# CITY OF ALBUQUERQUE

**Re: Winrock Town Center – Phase B  
2100 Louisiana NE  
Revised Grading and Drainage Plan  
Engineer's stamp date: 7/17/17 (J19D058E)**

**RE: Winrock Town Center – Phase B (J19D058E)  
Grading Plan, Engineer's Stamp Date: 3-11-2016**

**A1 GRADING PLAN**  
SCALE 1"=30'

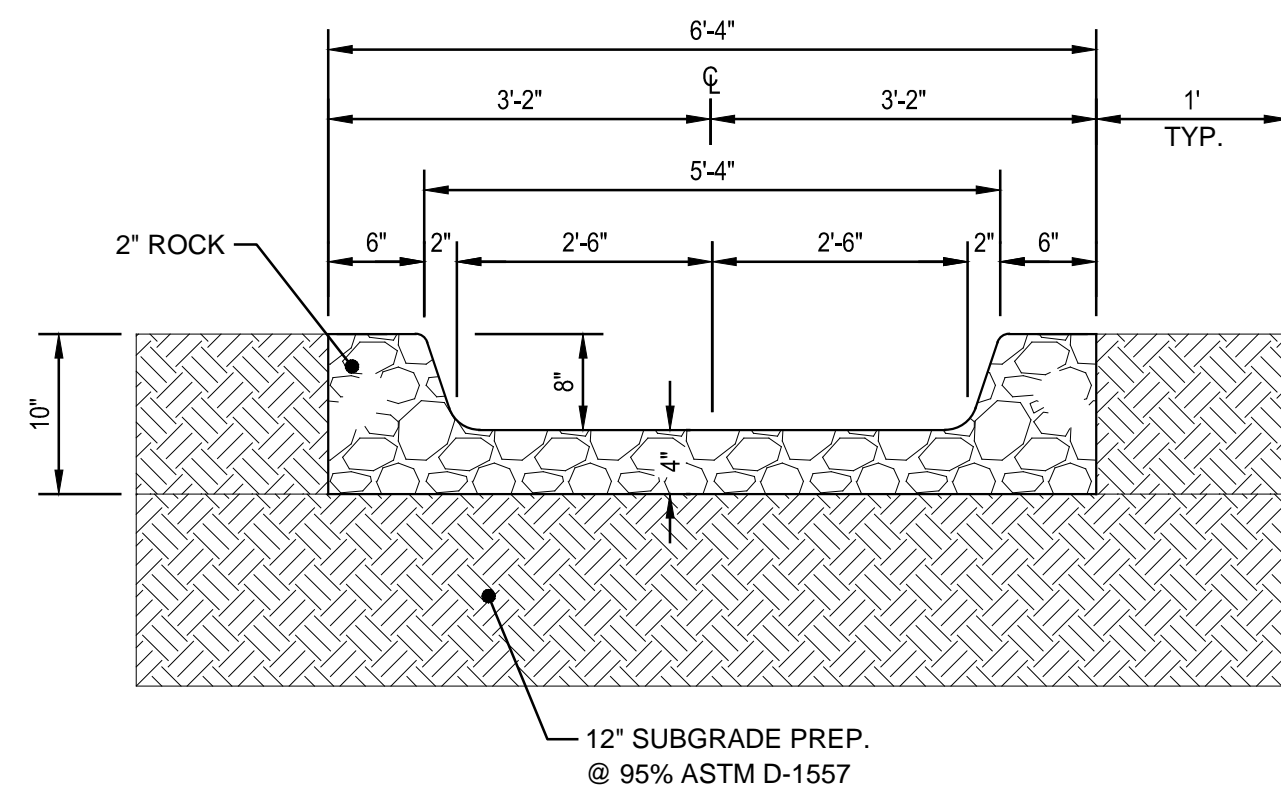
1. This grading and drainage plan needs to include all exterior improvement on the site, especially the design for draining the problem areas noted on the east side of the building at the last Hydrology inspection (6/22/17). Exterior work affecting drainage cannot be deferred to tenant improvements.
2. The rock lined channel needs to account for freeboard (see DPM Ch22.3.C.4). Also the channel slope does not match what's shown on the grading plan and a rectangular rock-lined channel does not seem constructible.
3. How does pond 2 outfall to the ROW?
4. Show the slope of all storm drain pipes on the plan.
5. Show the invert in and invert out on all inlets.

- Show the slope of all storm drain pipe on the plan
- Show the Invert in and invert out on all inlets
